**KILDARE COUNTY COUNCIL
PLANNING DEPARTMENT**

Report for submission to the members, prepared in accordance with Part XI, Section 179, Sub-section (3)(a) and (3)(b) of the Planning and Development Act 2000 as amended.

Type of Development	Refurbishment and Extension of Existing Newbridge County Library
Site Location	Newbridge County Library, Main St and Athgarvan Rd, Newbridge
Development proposed by	Strategic Projects and Public Realm
Display period	Advertised in the Leinster Leader and Kildare Nationalist published 9 th May 2023. Public display period from 10 th May to 21 st June 2023. Submissions could be made by 21 st June 2023.
Submissions/observations	17 No. submissions received. A Report on the submissions is included in Appendix B. A list of people who made submissions/observations is provided in Appendix C
Part 8 Reference Number	P82022.21

Fig 9: Site Layout Plan

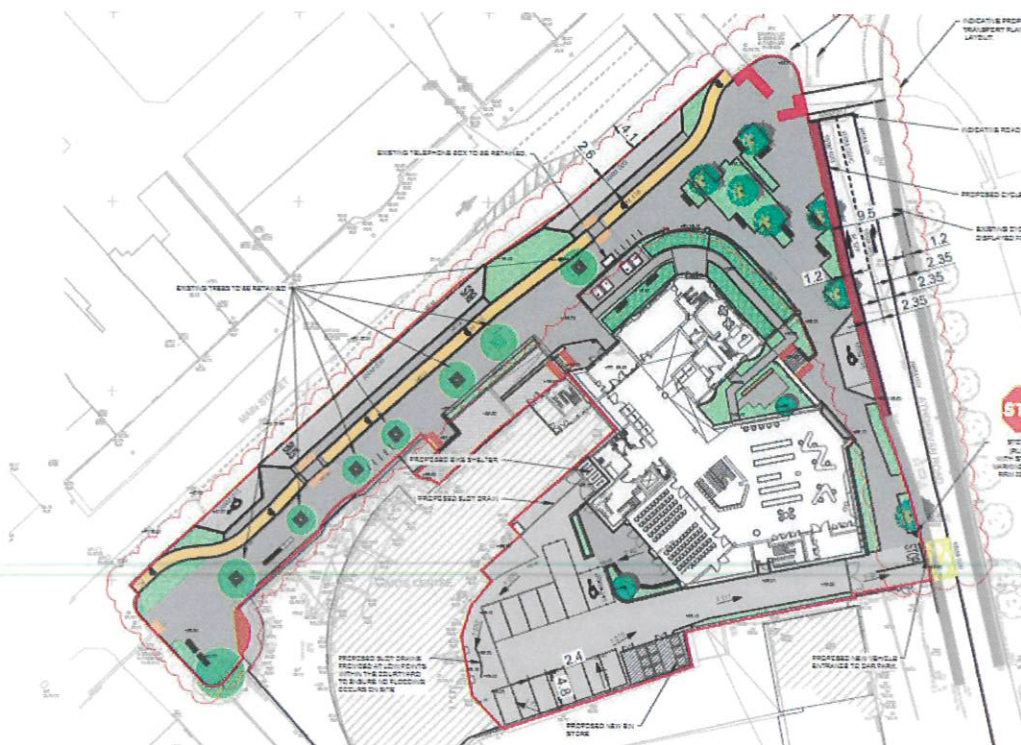
the relocation of the vehicular entrance from Main Street to Athgarvan Road, landscaping works to create a new external courtyard (707 sqm) including 13 no. parking spaces, a bicycle parking store and a refuse store. Public Realm works (2365 sqm) include new hard landscaping to the footpaths around the library, modifications to the Main Street public realm to provide a loading bay, bus stop and 2 no. accessible car parking spaces alongside the provision of a new cycle lane.
